Technical Bulletin

Bulletin No: TCH-001-044-A

**Subject: UNLOADER PISTON CHANGE FOR THE TF-550/750
COMPRESSOR**

New Style Unloader Piston

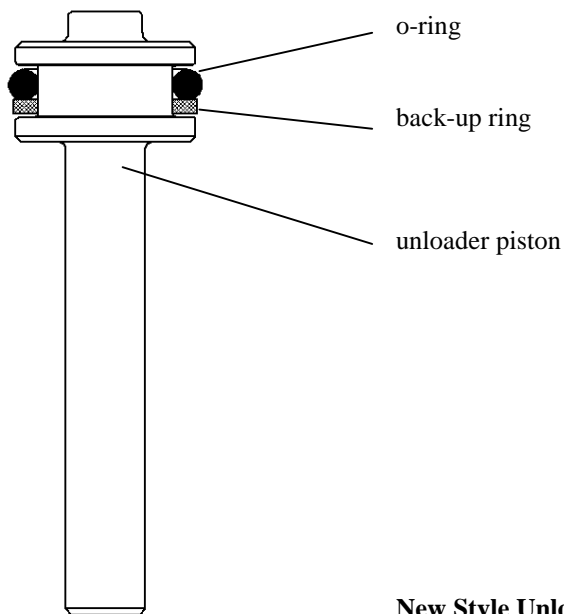
A design change has been incorporated into the unloader piston complete of the Tu-Flo 550 and Tu-Flo 750 air compressors. To minimize compressor unloader leakage a back-up ring was added to the unloader piston o-ring groove. The back-up ring enhances the seal between the unloader piston and unloader bushing.

The new and old style unloader pistons are interchangeable without the need for additional modification to the cylinder head. The new style unloader pistons are available in the following kits:
